CITY OF West Linn

STAFF REPORT FOR THE PLANNING COMMISSION

FILE NUMBER: DR-23-01

REQUEST: The applicant is requesting approval for the demolition of two existing structures, to be replaced with a two-story commercial building with underground parking and a rooftop deck at 1919 and 1949 Willamette Falls Drive.

2 SECOND FLOOR PLAN + EAST & 12th STREET ELEVATIONS

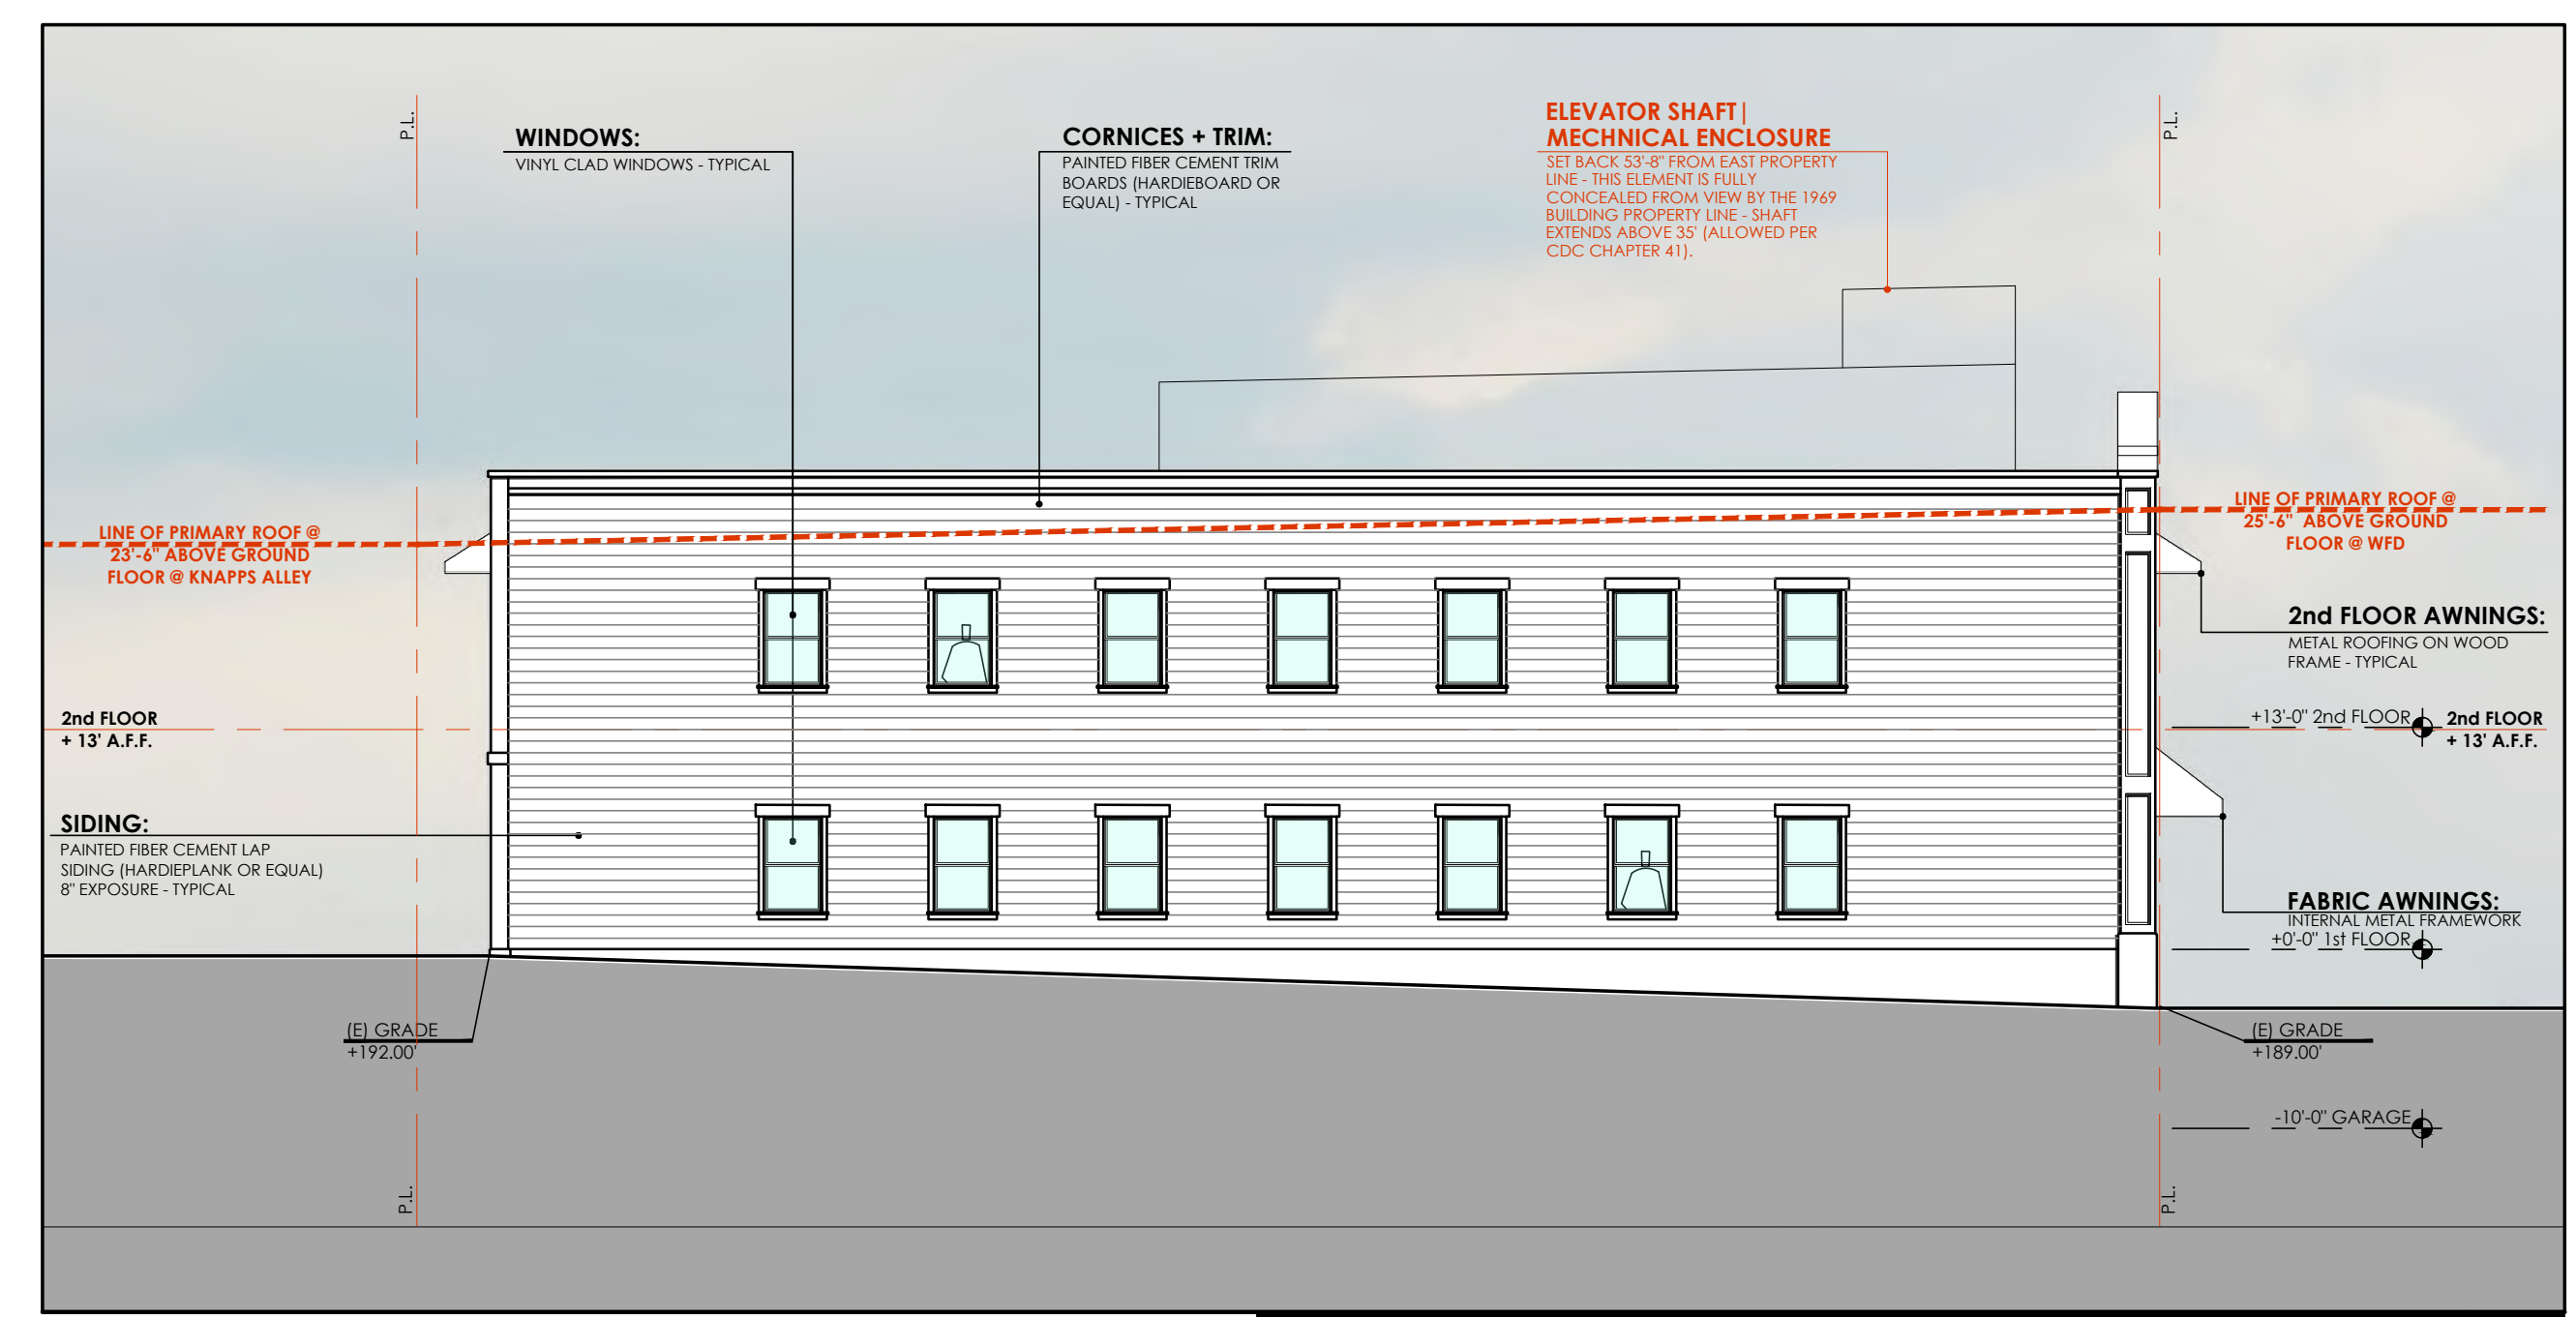
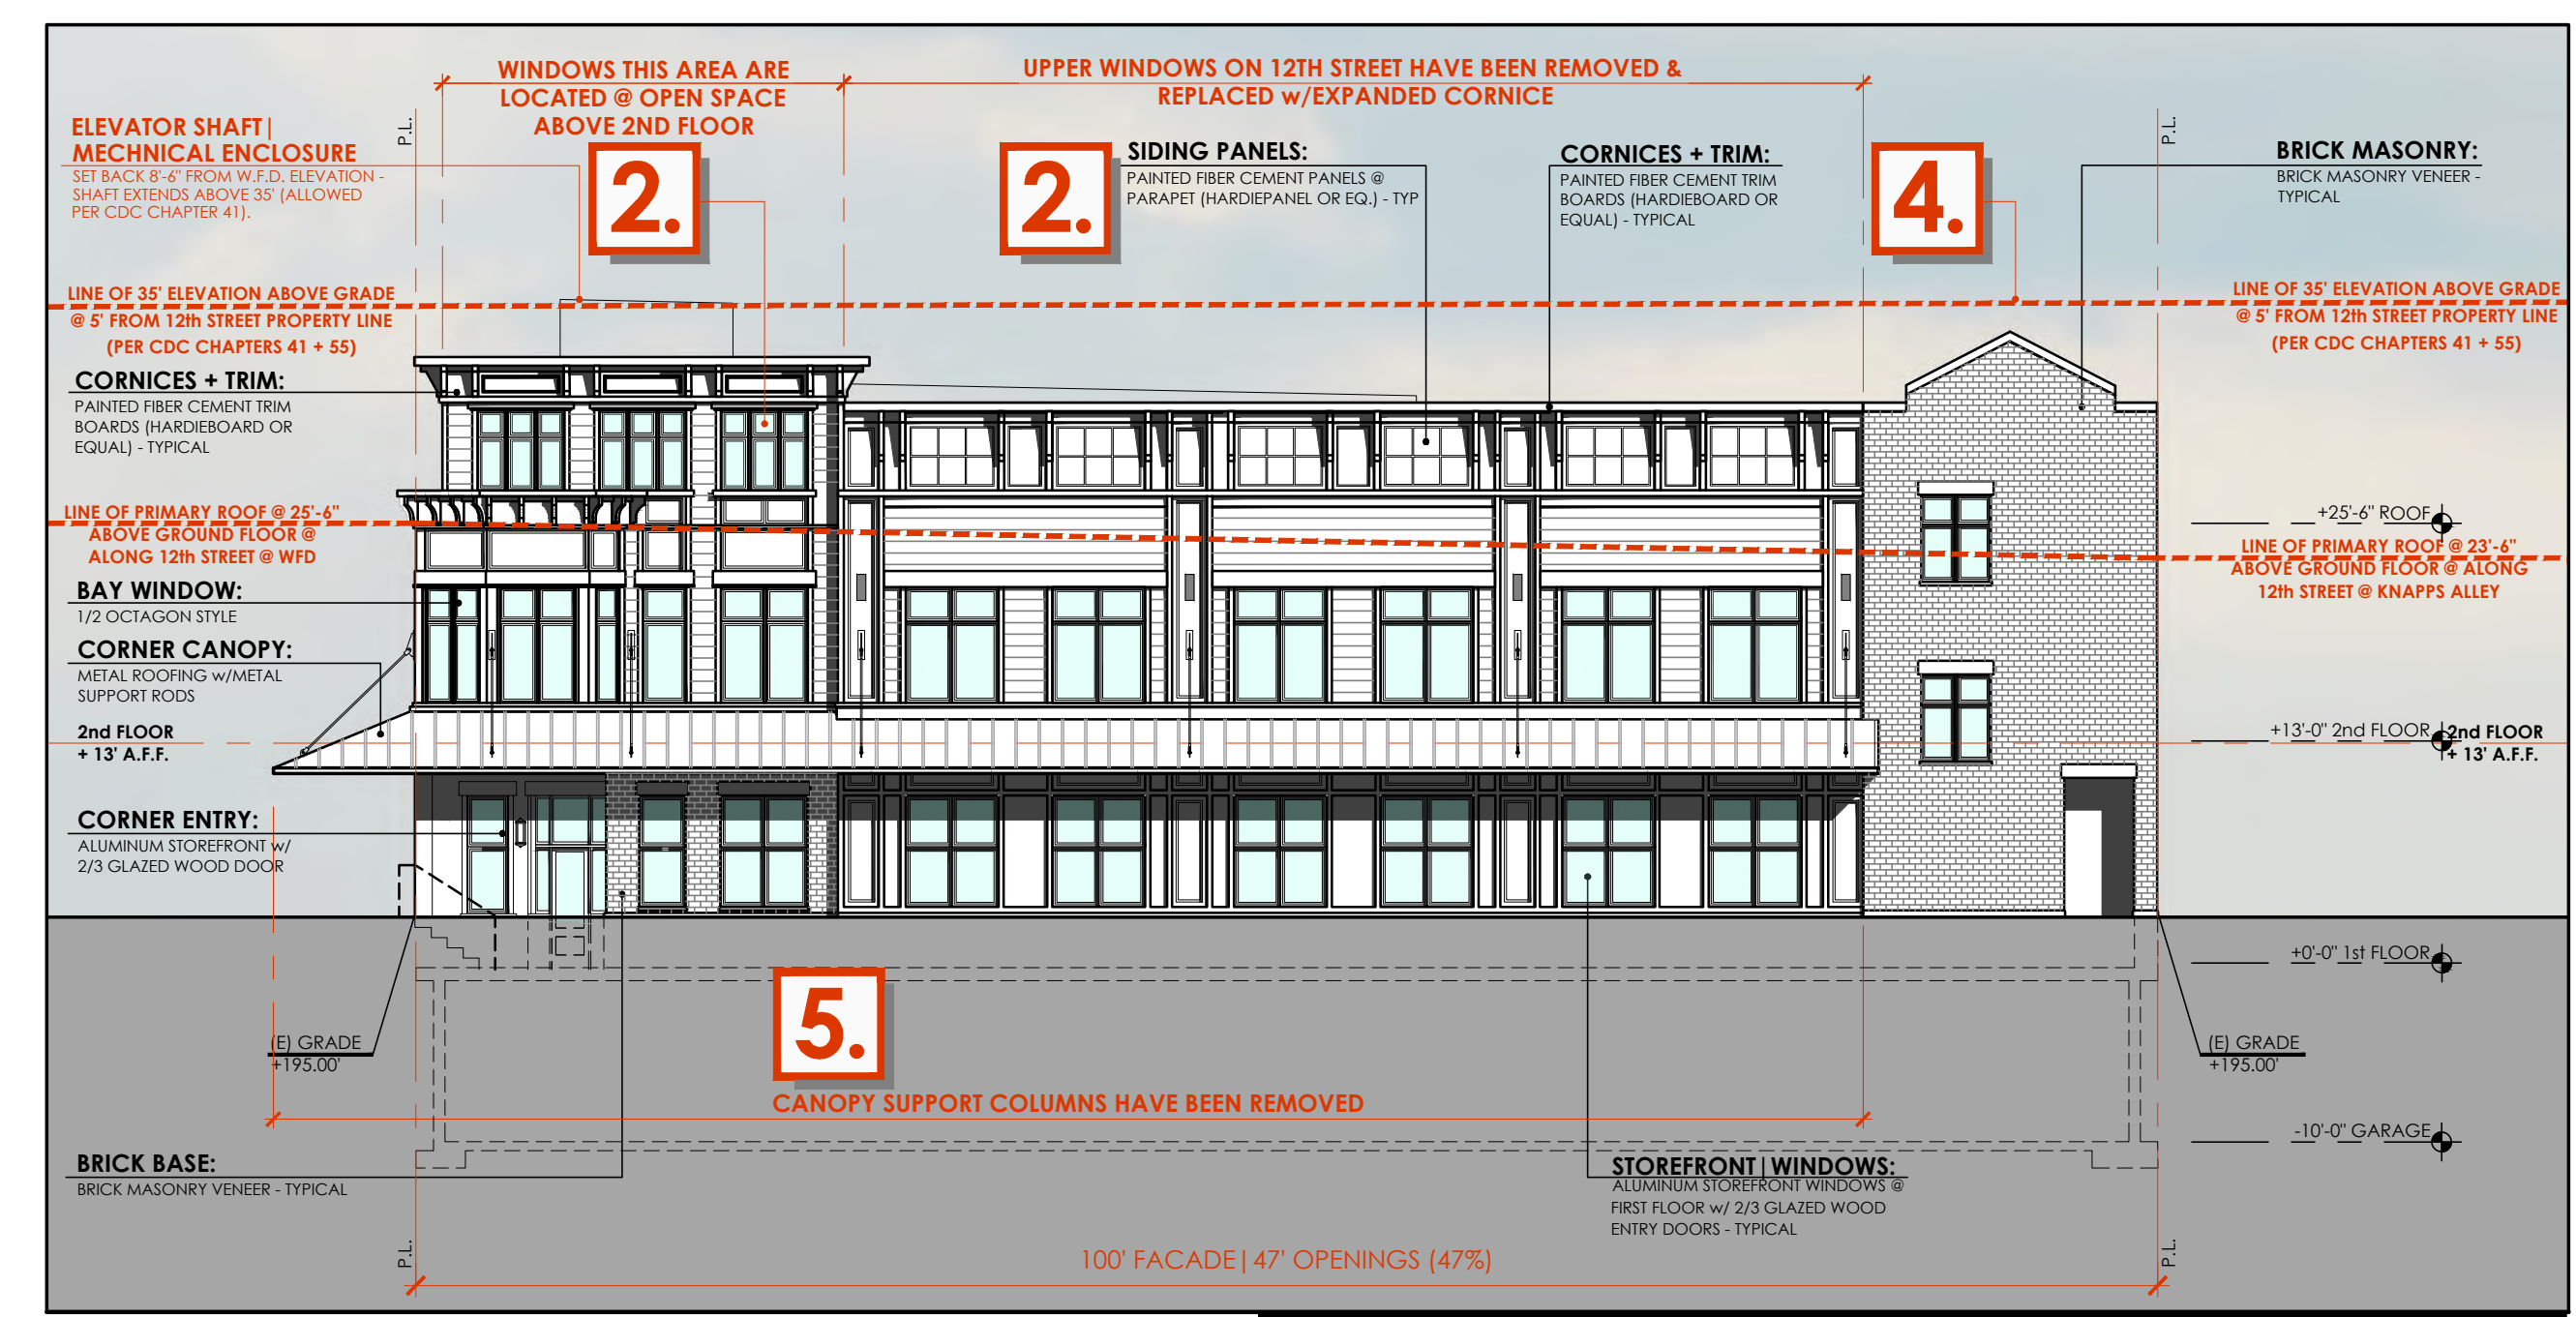
6. **Vertical Breaks.** Prior to issuance of building permits, the applicant shall submit building permit plans with revised western and southern elevations that demonstrate compliance with CDC 58.080.C.7 that requires strong vertical breaks or lines regularly spaced every 25 to 50 feet.

1. THE ENCLOSED ROOFTOP LOUNGE, RESTROOMS, AND SECOND ELEVATOR AND STAIR HAVE BEEN ELIMINATED. A HVAC EQUIPMENT SPACE WAS ADDED ADJACENT TO THE MAIN ELEVATOR TO HELP TO MITIGATE NOISE FROM THE HVAC UNITS. THE OUTDOOR ROOF DECK REMAINS - WITH A SCREEN SURROUND - FOR GENERAL USE BY TENANTS AND GUESTS.

2. THE WINDOWS ALONG 12th STREET WERE REMOVED AND REPLACED WITH A REDESIGNED CORNICE, PAINTED PANELS, AND PAINTED VERTICAL PILASTERS, BREAKING UP THE FACADE INTO VERTICAL COMPONENTS. THE CLERESTORY WINDOWS REMAIN AT THE NW CORNER PROVIDING ADDITIONAL NATURAL LIGHT TO THE SECOND FLOOR.

5. THE CANOPY SUPPORT COLUMNS HAVE BEEN ELIMINATED AS REQUESTED BY ENGINEERING. THE CANOPY WILL BE SUPPORTED BY TIE-BACK RODS MATCHING THOSE ORIGINALLY APPROVED ON THE 1969 WFD BUILDING.
